Code-Making Panel 2 Public Input Report (A19)

Public Input No. 3453-NFPA 70-2017 [Global Input]

EXHIBIT 1

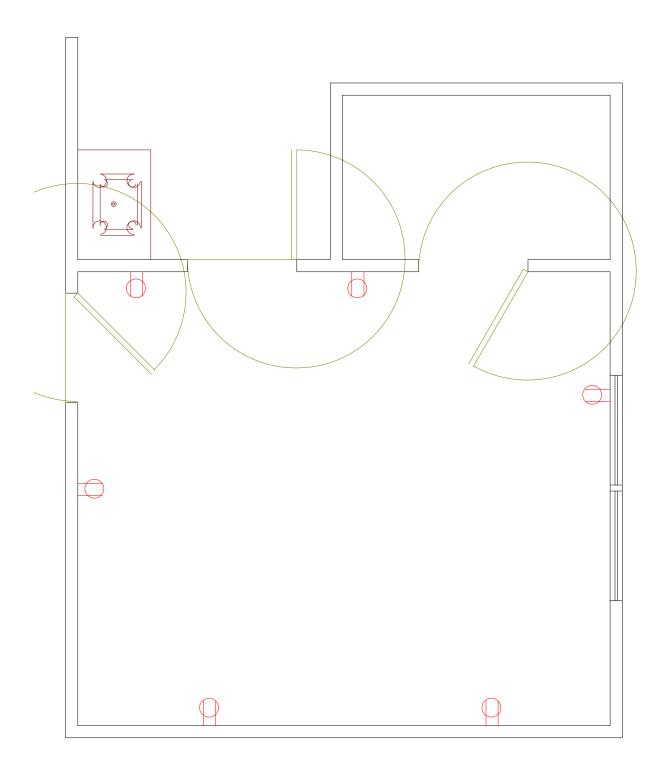
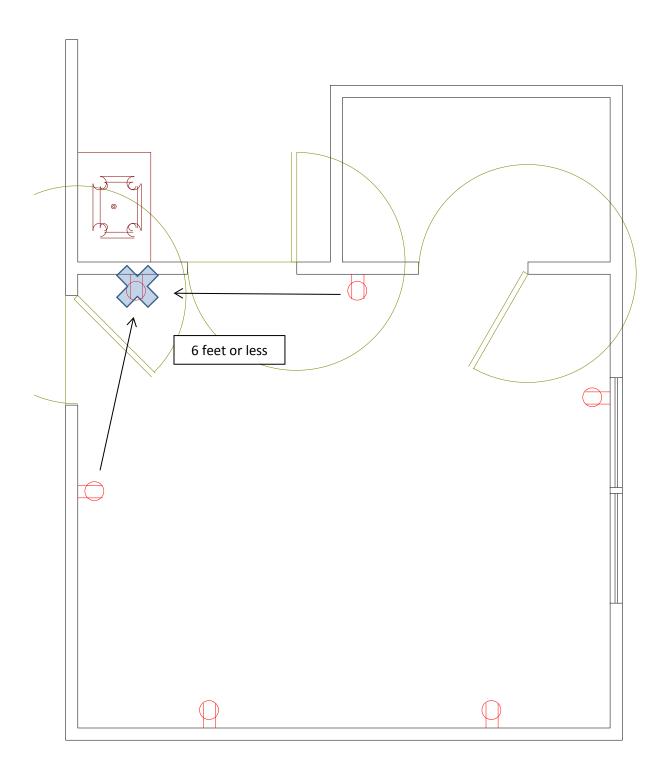
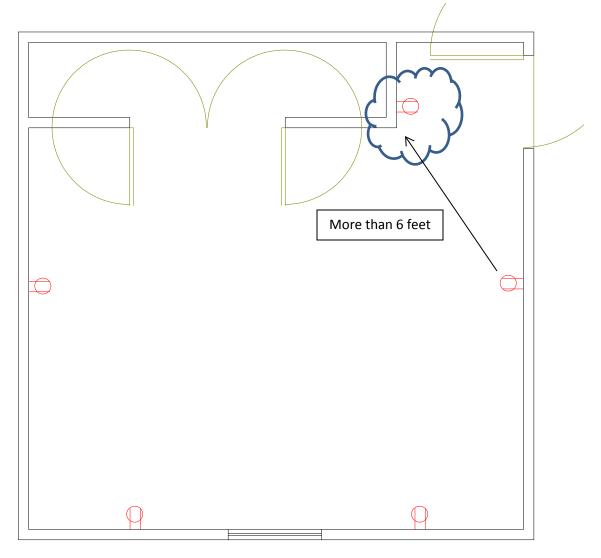
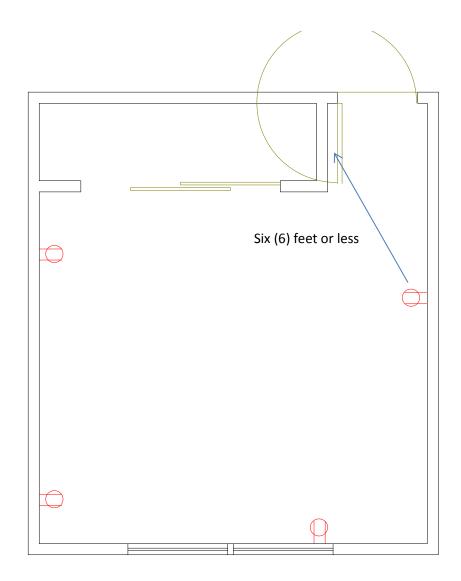
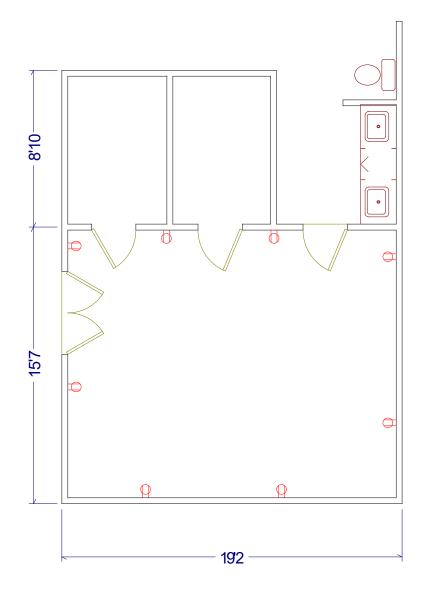
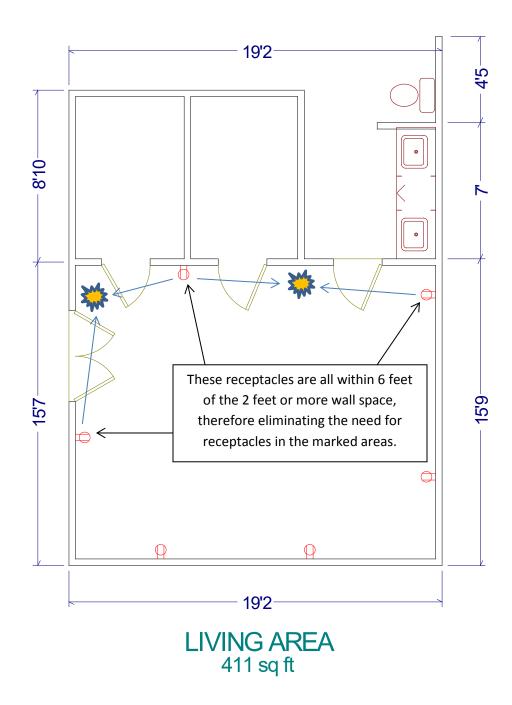
Applying the exception to this scenario, the receptacle behind the door will not be installed as there are other receptacles within 6 feet of that space.

In this example, the entrance door swings in a different way and when placing the receptacle as required in 210.52(A)(2)(1), such receptacle will be behind the door. The purpose of the exception is to 1) eliminate receptacles behind doors and 2) limit the amount of receptacles in odd locations. With the exception you will not place a receptacle at this location if there is a receptacle outlet within 6 feet of the space.

This is a good example where you have several doorways and openings and the space is more than 2 feet. Every wall space must have a receptacle. See Exhibit 5.

By looking at Exhibit, the placement of receptacles is as good as 210.52(A)(1) and you will not end up with receptacles in odd locations .

Figure 210.52(C)(1) Determination of Area Behind a Range, Counter-Mounted Cooking Unit, or Sink.

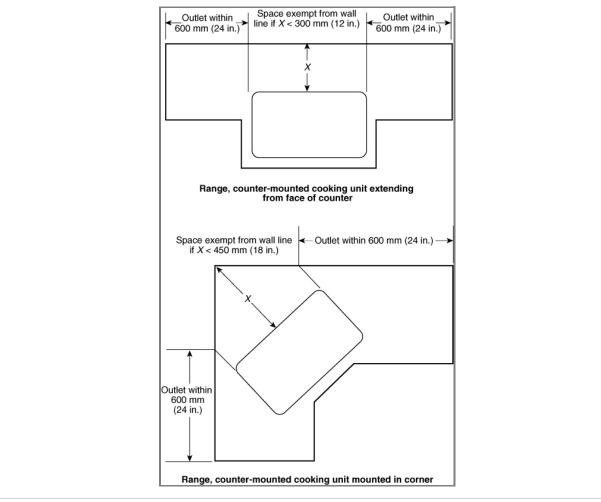
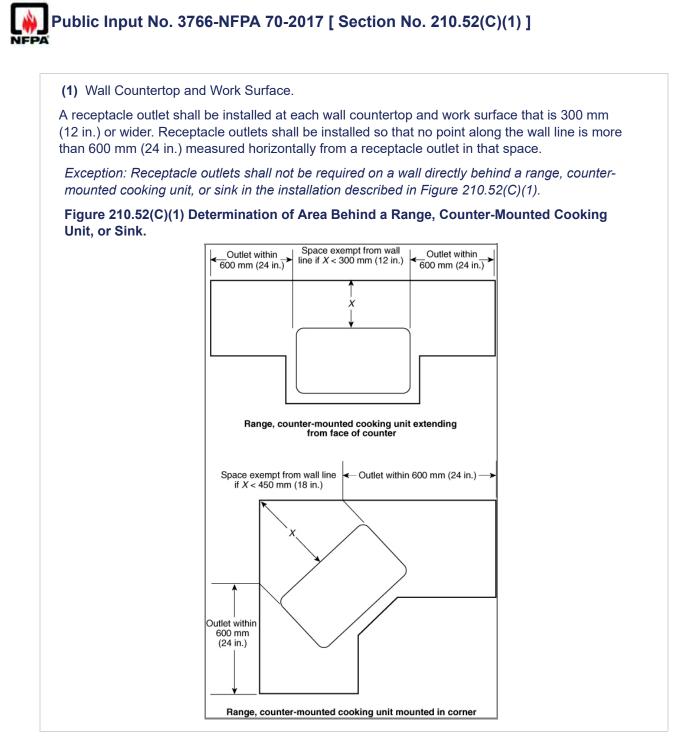
My intention is to replace Figure 210.52(C)(1) with the figure provided as a graphic. The caption for the

The upper drawing in Figure 210.52(C)(1) needs to be revised as shown as most commonly, countermounted cooking units, rangetops and sinks do not extend from the face of kitchen counters. And, that is not the issue being addressed. This section addresses whether or not a receptacle outlet is needed for a wall space. It is not uncommon for a range to extend beyond the face of the lower cabinet but that feature is not shown in either drawing. The figure should also be used for 210.52(C)(4) to illustrate "Separate Spaces". The appliance or sink create a separation of the counter top for the purpose of determining the appropriate placement of receptacle outlets. If there is less than the prescribed distance shown at the "X", a receptacle is not required.
